DC power

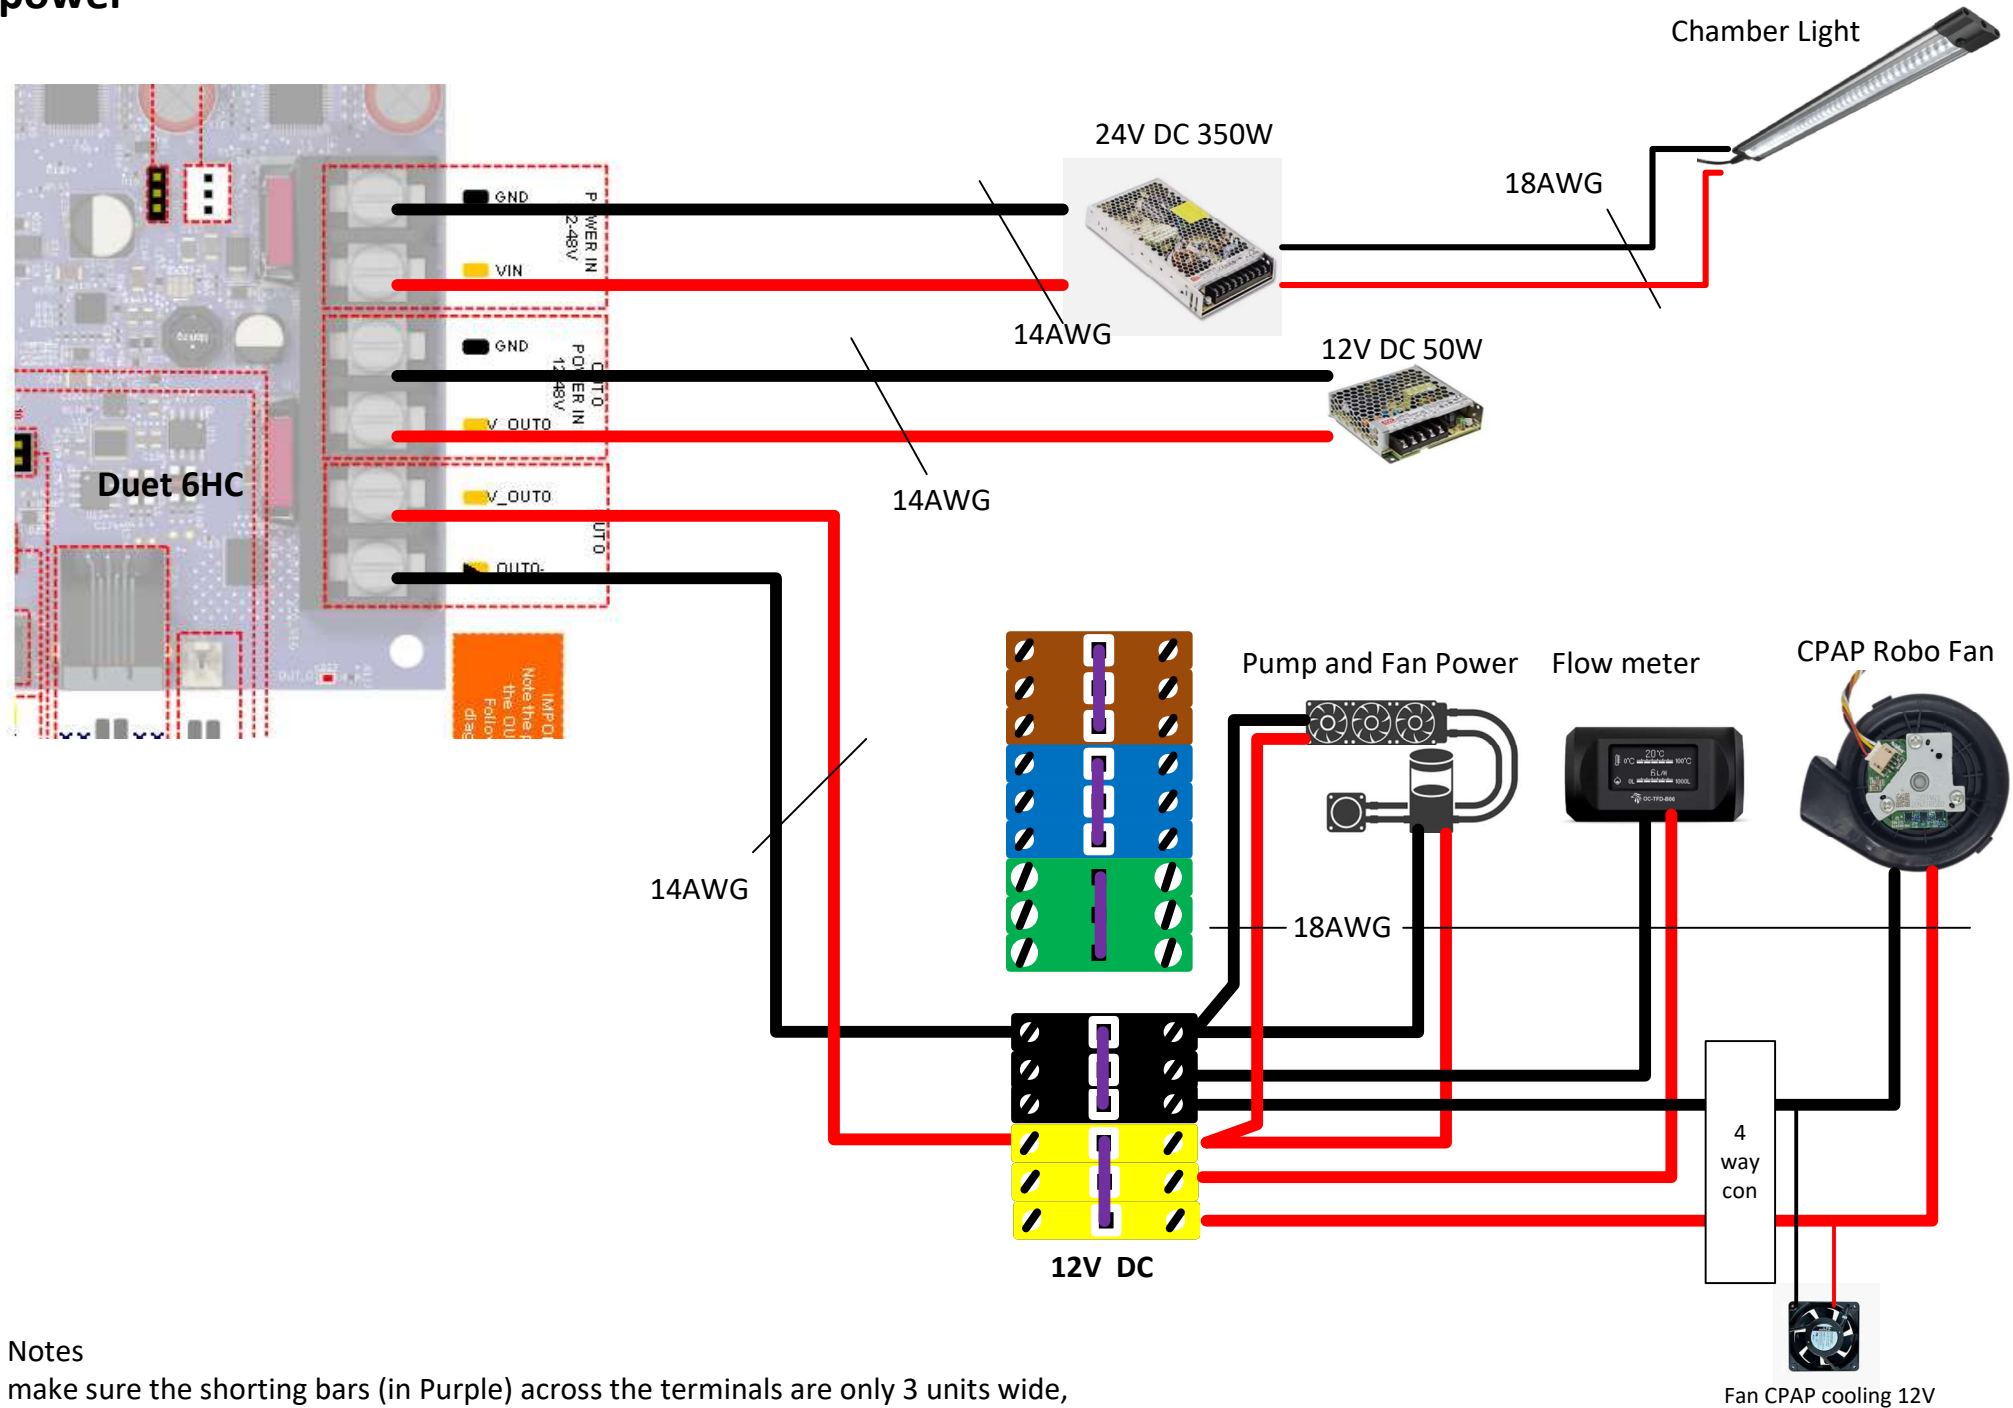
make sure the shunting bars (in Purple) across the terminals are only 3 units wide, and spacers inserted between each block of 3
